Determination 2013/014

The compliance of a stair to proposed alterations to a cattery at 160 Main North Road, Papanui, Christchurch

Excerpt from Figure 11

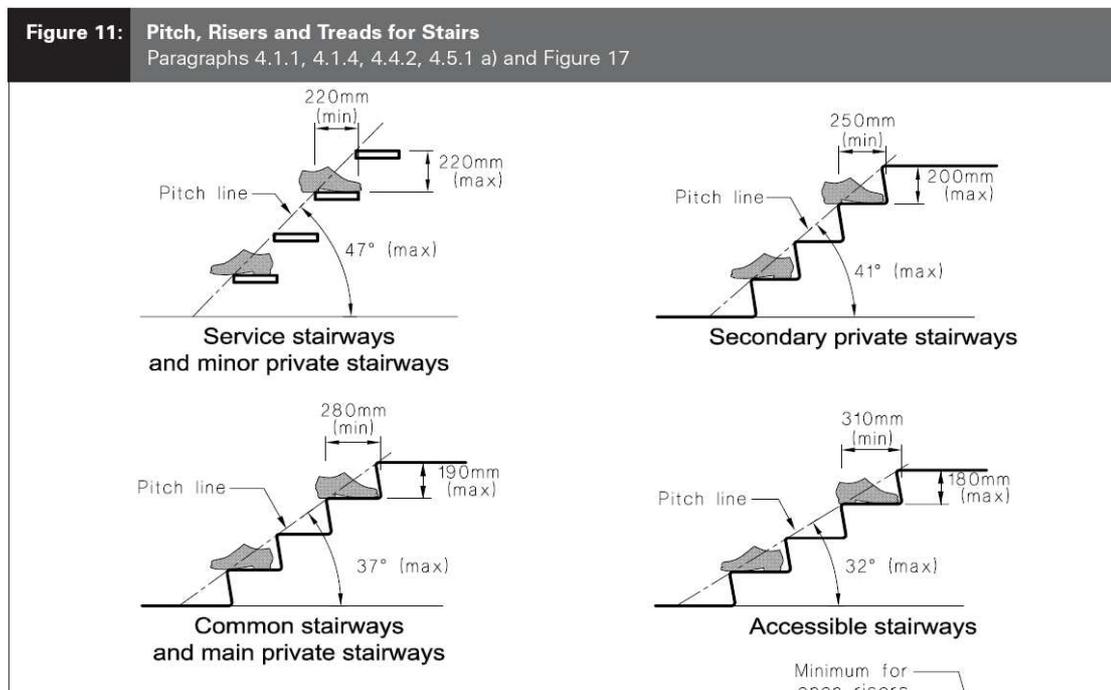
5.2.2 As described in paragraph 2.2, the proposed stair has a tread depth of 285mm and risers that are 172mm high with a pitch of 33.5°. In this respect, a comparison with Figure 11 of D1/AS1 indicates that the stair meets the requirements for a common stair. However, while the stair riser height of 172mm is less than the 180 maximum shown in Figure 11 for an accessible stair, the tread depth does not meet the minimum 310mm requirement. The maximum pitch of an accessible stair is 32°; the maximum pitch of a common and private stair is 37°.

Figure 17: Curved Stairway with Tapered Treads
Paragraphs 4.4.1 a) and b) and 4.5.2

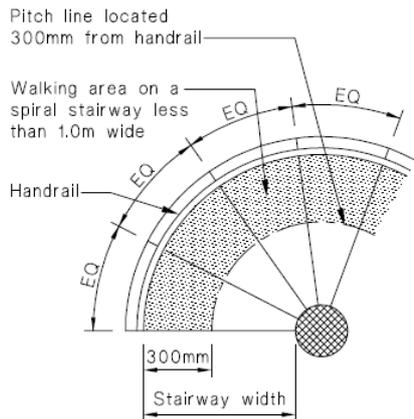
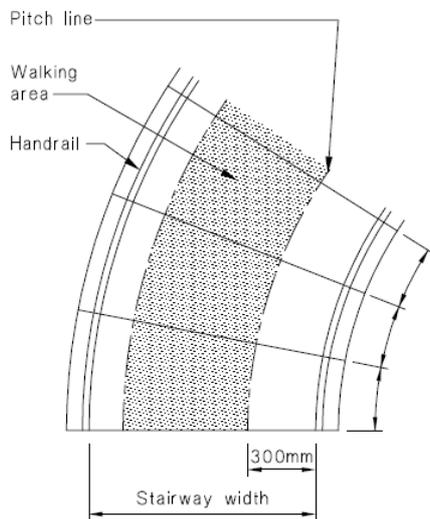
- 5.2.7 The authority has submitted that the winders should be compared with figure 17(b) in D1/AS1 which is for a curved stairway clear width between handrails of 1000mm or greater which is acceptable as an accessible stairway.

- 5.2.8 Curved and spiral stairs are considered in paragraph 4.4 and described in figure 17 of D1/AS1: the comment on paragraph 4.4 says '[the] dimensions of Figure 17 are based on the assumption that people walk up and down only on the outside of a narrow stairway, but both the inside and outside of wider stairways'.

- 5.2.9 The proposed stair has a clear width less than 1000mm and given the comment on paragraph 4.4 of D1/AS1, I consider figure 17(b) is more appropriate for considering the point on the stair where the pitch line should be considered

Figure 18: Stair Winders
Paragraphs 4.5.1 and 4.5.2

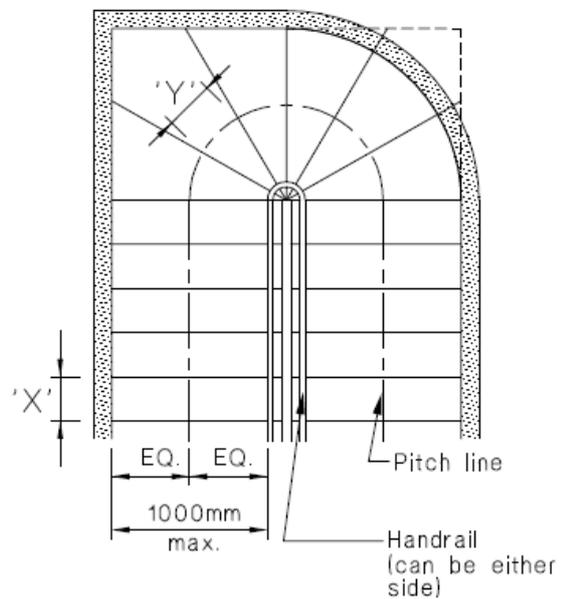
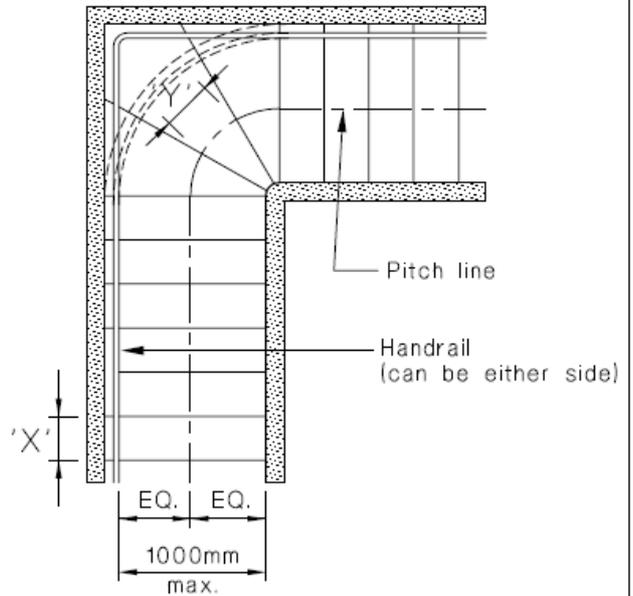
- 5.2.6 I consider this minimum dimension should be applied in this instance to ensure that the winder treads are a safe depth, and the winders will meet the minimum requirements for winders as they are described in Figure 18 and Clause 4.5 of D1/AS1.

(a) Winder flight with three treads
Figure 7. Clear width and going on winder flights

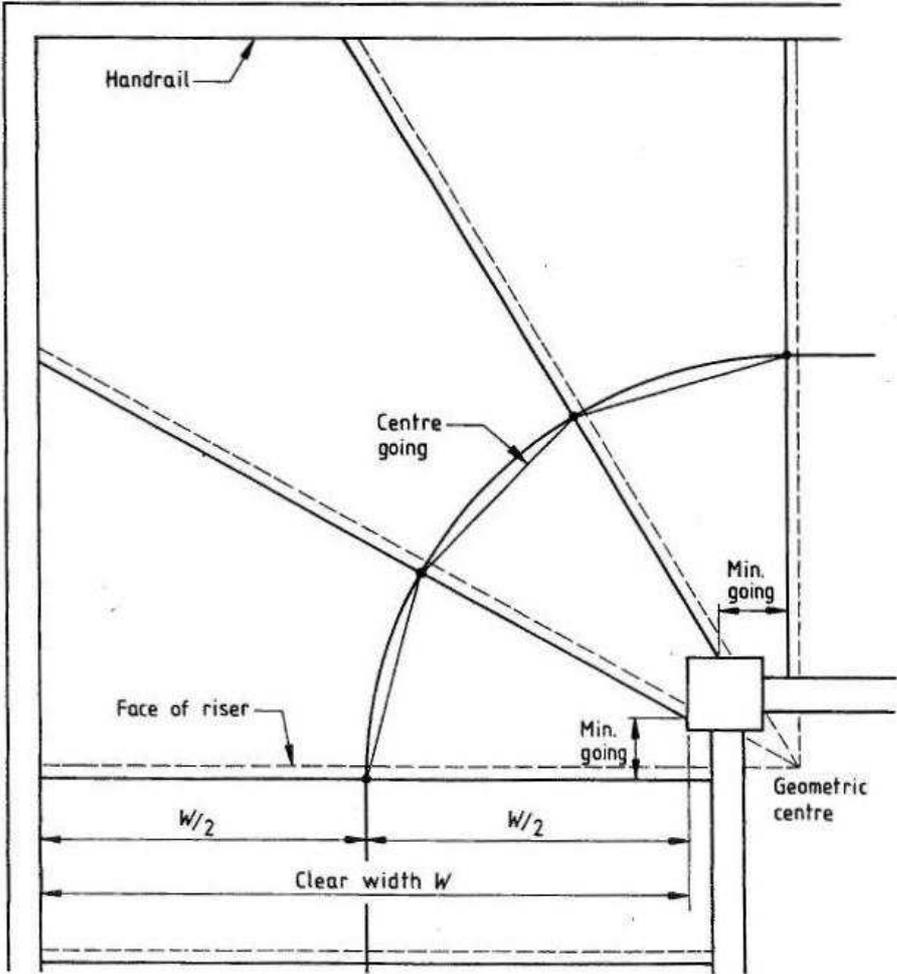
- 5.2.5 The proposed winders are a more significant departure from D1/AS1 as their inclusion means that the stair does not comply with either the accessible stair or the common stair requirements as described in D1/AS1. D1/AS1 says that BS585: Part 1¹¹ is an acceptable solution for winders on stairways of this width. It is noted that Figure 7 of that standard (refer Appendix) requires a minimum going which is described in Clause B1.3 of BS585 as not less than 75mm.
